## ADDENDUM 01

03.29.2023

Project: Anderson County Senior Center  
Phase 2 Improvements  
S4D Number: 20033  
Date of Bid Documents: 02.03.2023

To: Bidders of Record  
Copies: Owner, Anderson Co. Purchasing  
From: Rose Gowder, S4D

**3 Kitchen Equipment Schedule**  
NTS

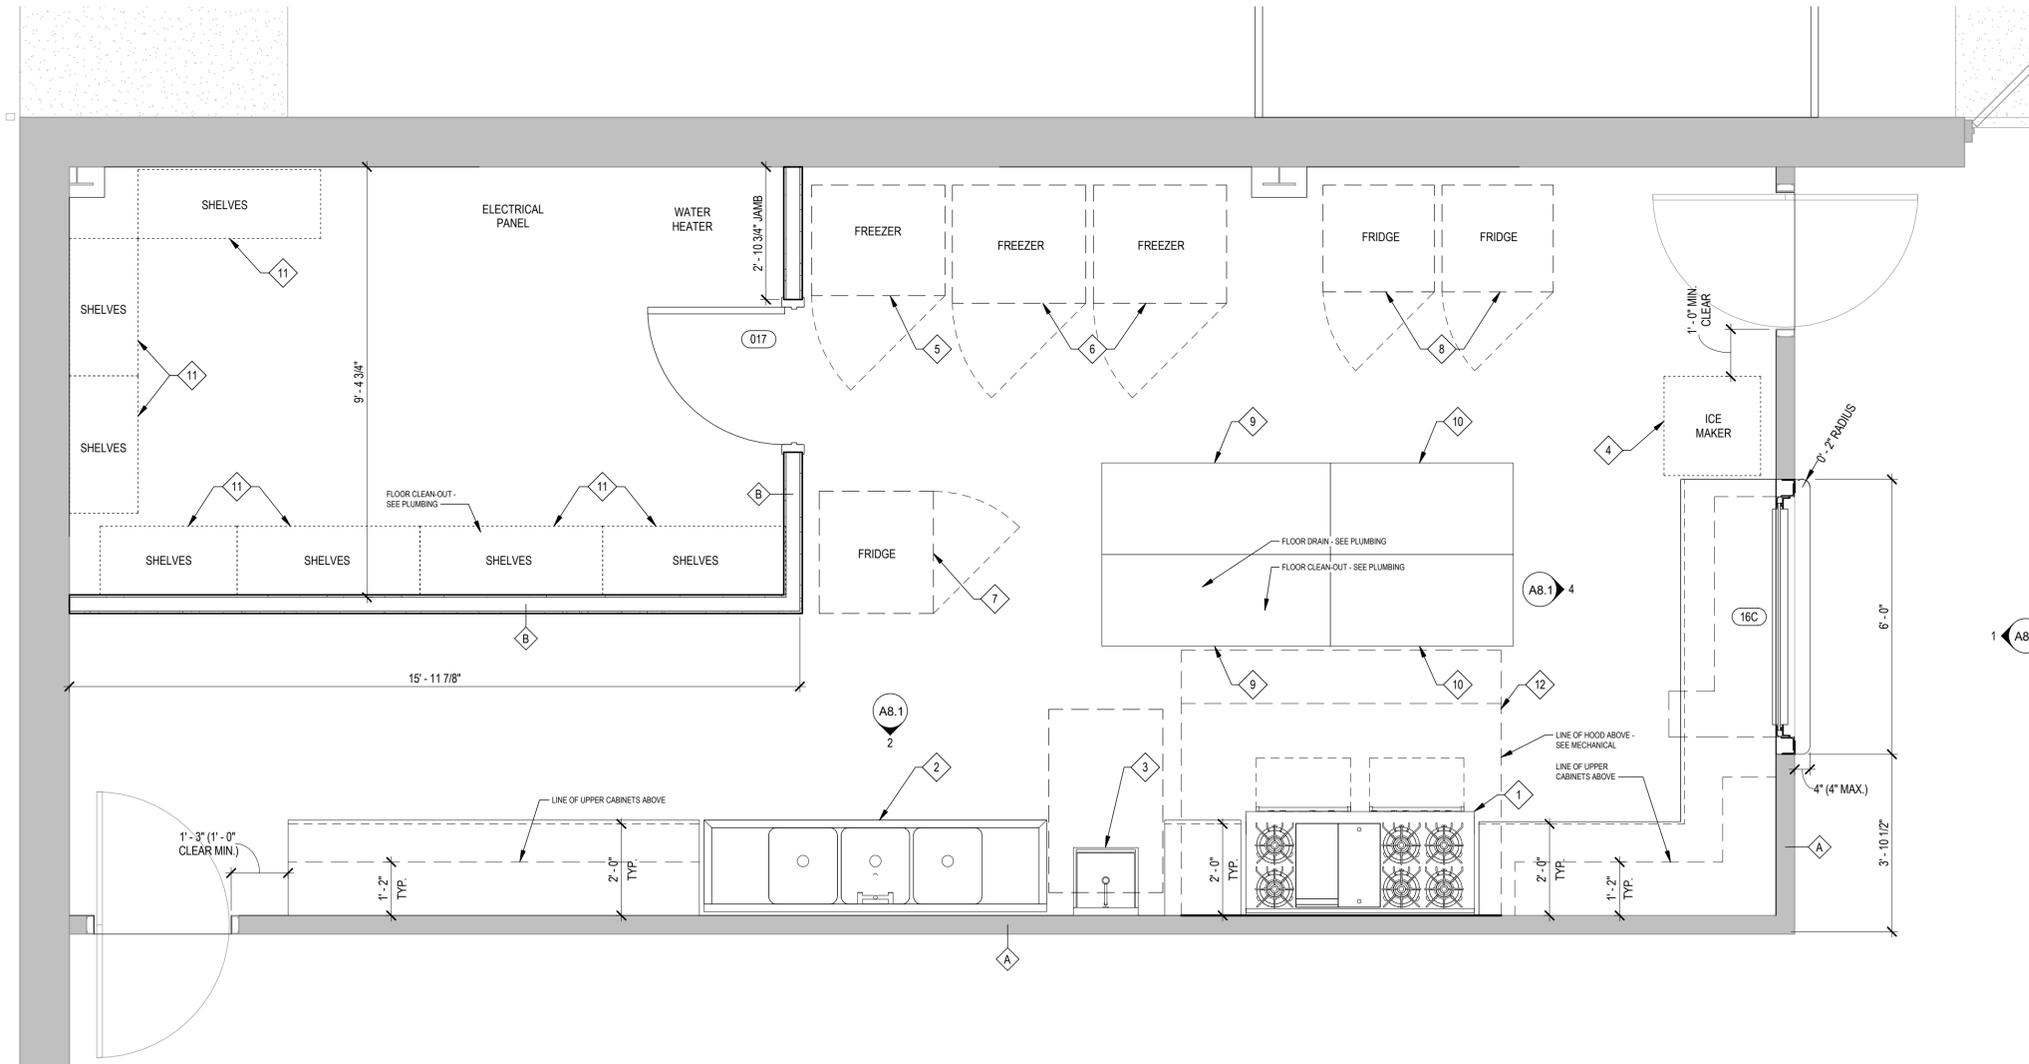
28. Drawing 3/A1.2 - Kitchen Equipment Schedule: Please confirm the Commercial Gas Range (item #1), 3-Compartment Commercial Utility Sink (item #2), and the Handwashing Sink (item #3) are furnished by the G.C.

29. Drawing 3/A1.2 - Kitchen Equipment Schedule: Please confirm the kitchen hood package is furnished by the G.C.

38. On page A1.2 in detail 3, the kitchen equipment schedule depicts some items to be owner provided. Contractor is responsible for items 1-3, and item 12 only?

Drawing A1.2, Kitchen Equipment Schedule item #1 revised to be owner provided.

**Response:** The owner has already acquired item #1, Gas Range. Items 2, 3, and 12 to be furnished by contractor.

**Response:** correct

**Response:** The owner has already acquired item #1, Gas Range. Items 2,3, and 12 to be furnished by contractor.

2 Add Alternate 3 - Walk-In Cooler Plan  
1/4" = 1'-0"

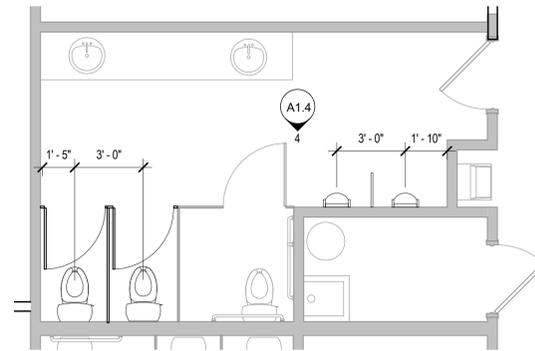
30. Drawing 2/A1.4: Please clarify if the walk-in cooler and freezer are furnished by the G.C. or the Owner.

34. Drawing 2/A1.4: An insulated concrete slab is shown for the walk-in cooler and freezer locations. Please provide specifications (thickness / insulation) requirements for the new concrete slab.

35. Drawing 2/A1.4: Please clarify what the new concrete pad dimensions are for the new walk-in cooler and freezer.

Drawing A1.4, Add Alternate 3 – Walk-in Cooler Plan revised to show concrete pad dimensions.

**Response:** to be provided by the G.C.

**Response:** pour typical concrete slab for the cooler and freezer walk-ins. Outdoor cooler and freezer units to have manufacturer provided insulated floor system.

**Response:** Provide concrete pad 8'-4" x 12'-4"
